South Hadley Electric Light Dept IFB for the Telecom Substation Improvements

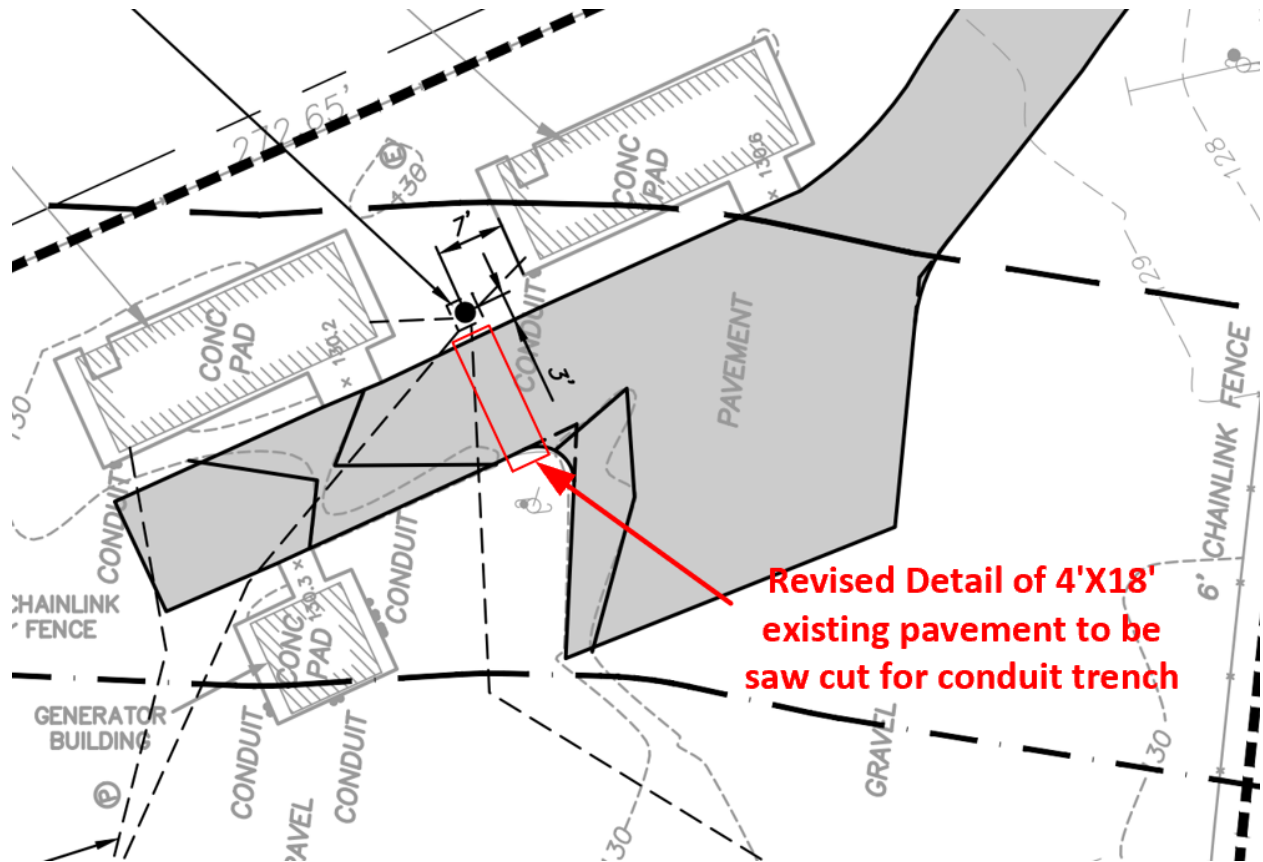
C. 7/28/2020 "at College Street" Q&A #2 The amount of pavement to be removed and replaced was described at the pre bid. Will you be issuing a revised plan depicting the new pavement?

Yes, see attachment. The owner has identified a simplified approach for conduit trench needed. Following bid award, a sketch plan can be issued for construction purposes.

SEE BELOW
